NOTICE OF DECISION

CLASS 3 SITE PLAN REVIEW /CLASS 2 ADJUSTMENT CASE NO.: SPR-ADJ22-31

SUMMARY: A proposal to construct a new Fred Meyer fueling station with associated site improvements.

PRELIMINARY SITE PLAN

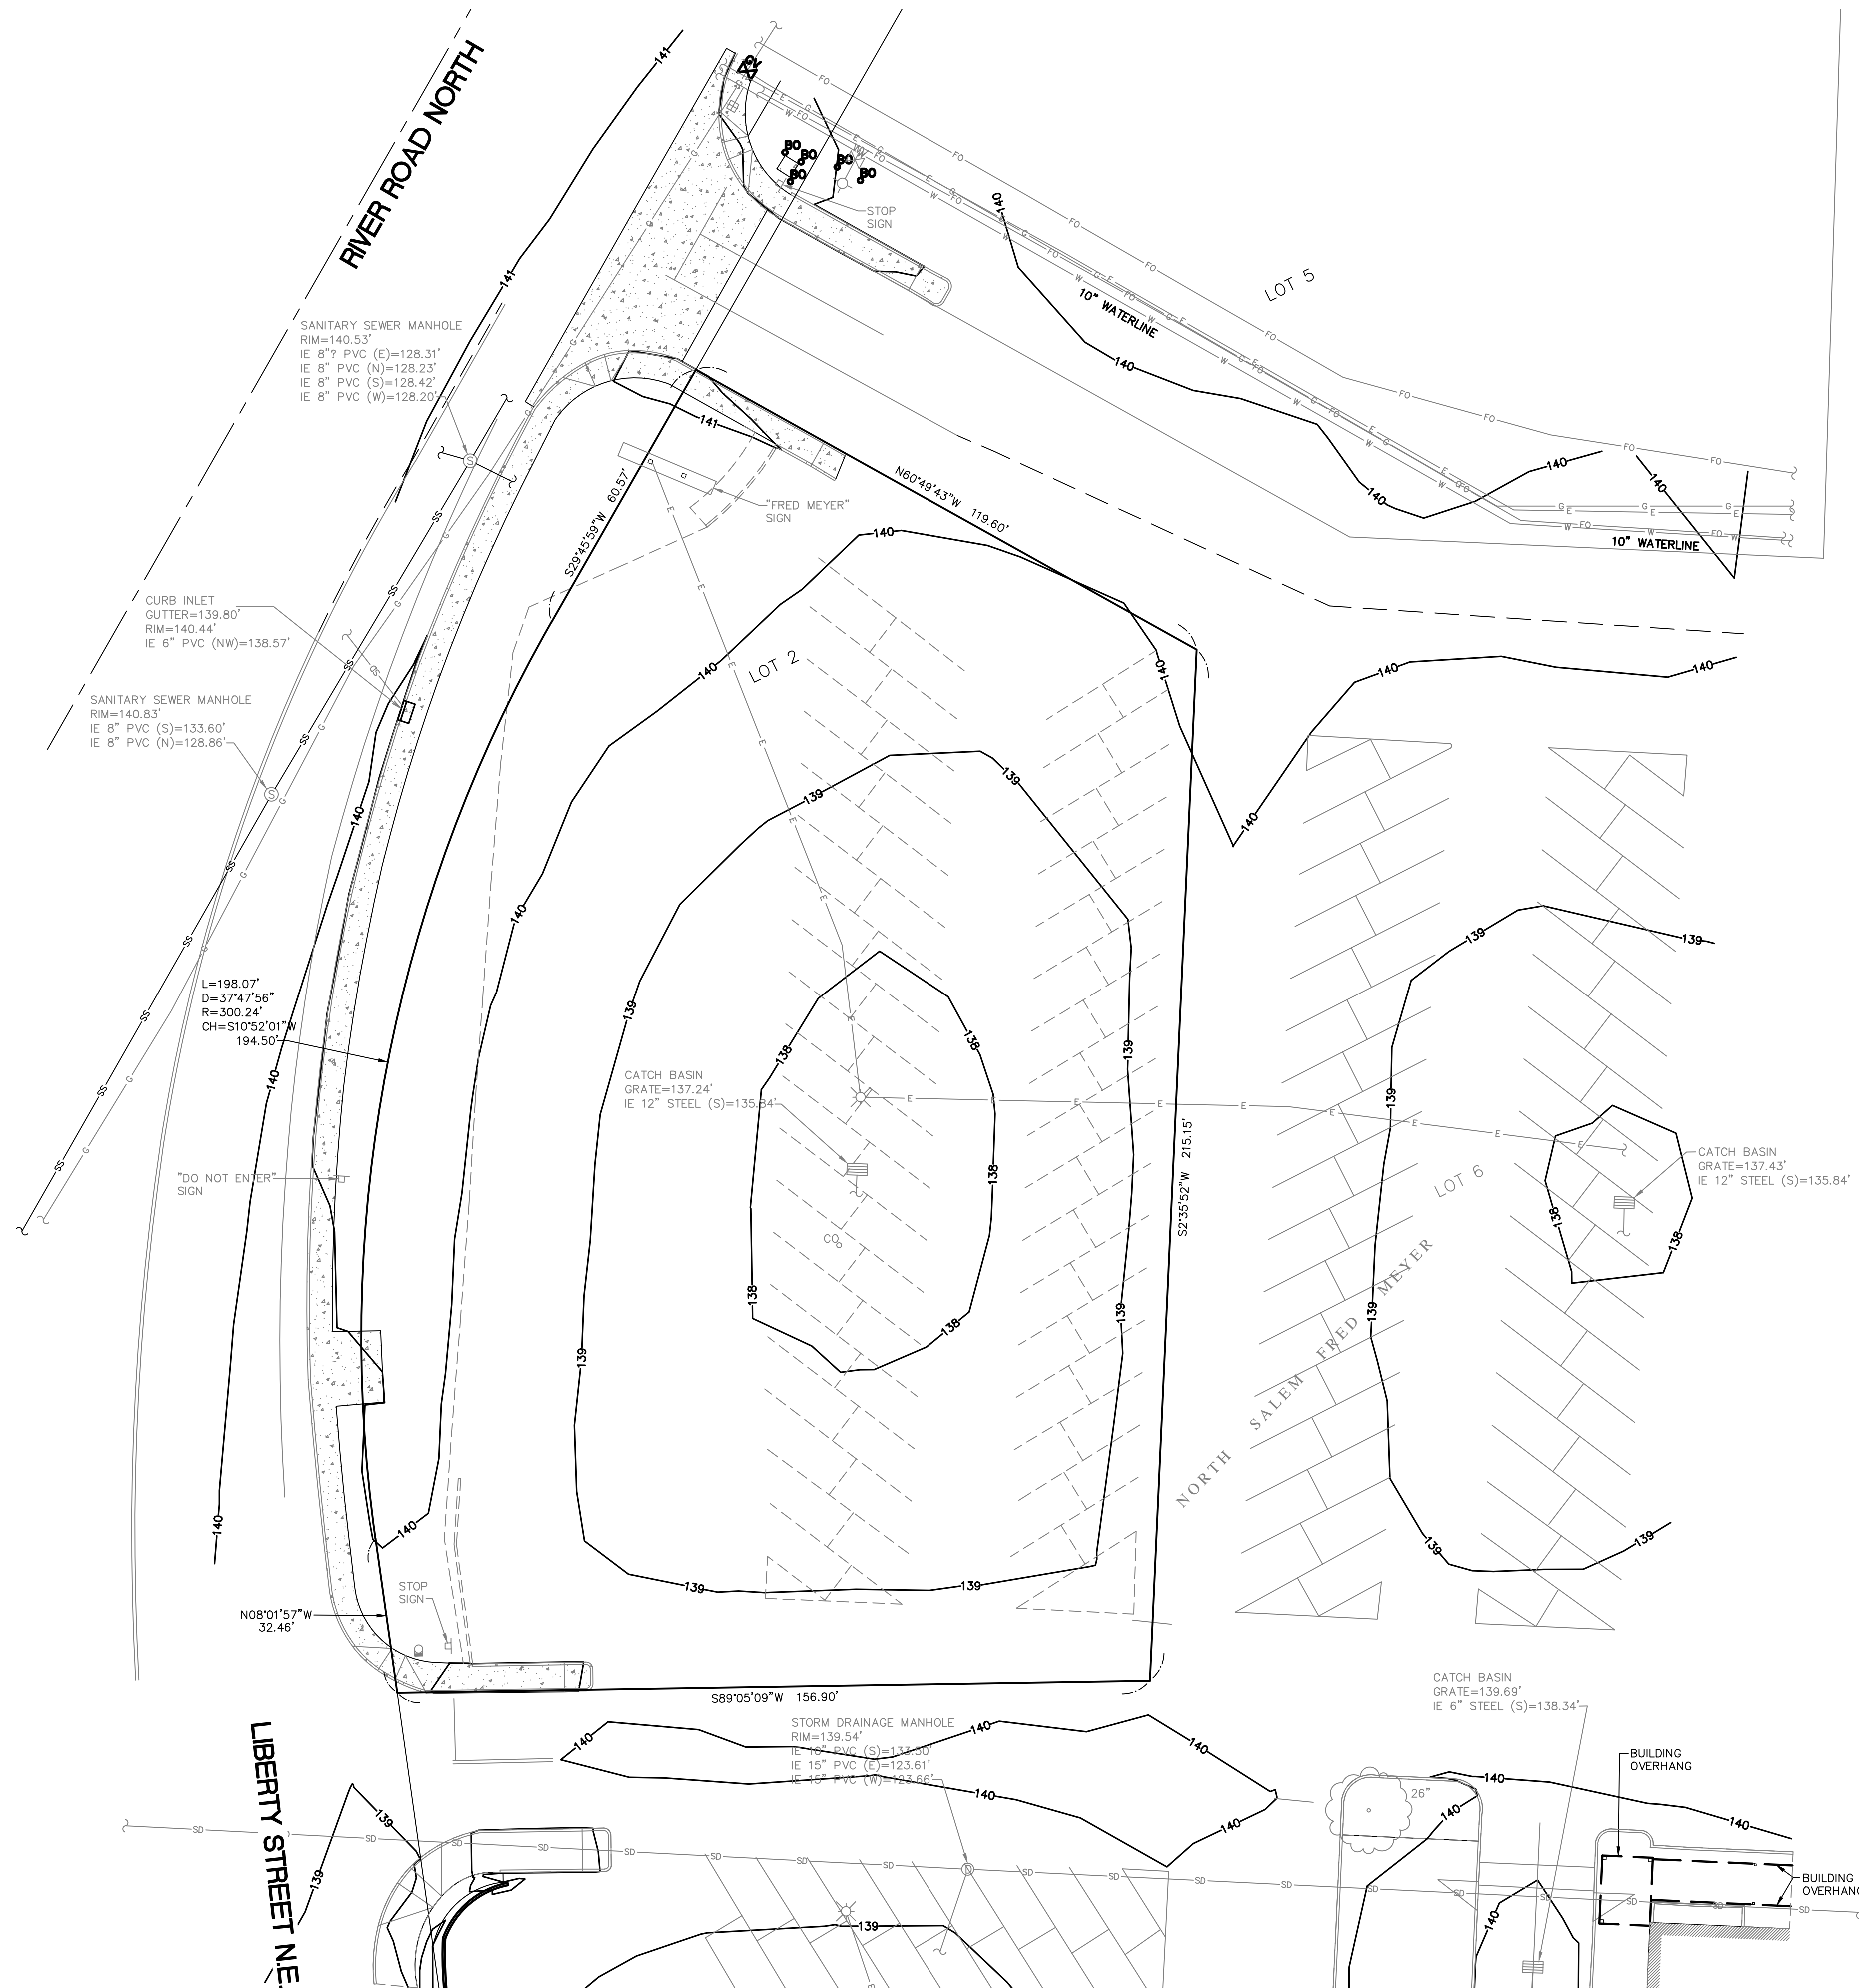
Finding: The existing driveway approaches and curb returns on River Road N do not meet current Public Works Design Standards for commercial approaches, the applicant shall replace the nonconforming driveway approaches. As conditioned, the driveway access onto River Road N and Liberty Street NE will provide for safe turning movements into and out of the property.

Finding: The Public Works Department has reviewed the applicant's preliminary plan for this site. The water, sewer, and storm infrastructure are available within surrounding streets/areas and are adequate to serve the proposed development. The applicant's preliminary site plan shows new water services crossing adjacent private property. The applicant is required to obtain easements for new City services on adjacent private property or demonstrate that an easement exists.

preliminary site plan shows new water services crossing adjacent private property. The applicant is required to obtain easements for new City services on adjacent private property or demonstrate that an easement exists.

Condition 2: Replace nonconforming driveway approaches and curb returns on River Road N and Liberty Street NE to meet current Public Works Design Standards for commercial development.

Condition 3: Provide public utility easements for City infrastructure on private property pursuant to PWDS.

Condition: Provide public utility easements for City infrastructure on private property pursuant to PWDS.
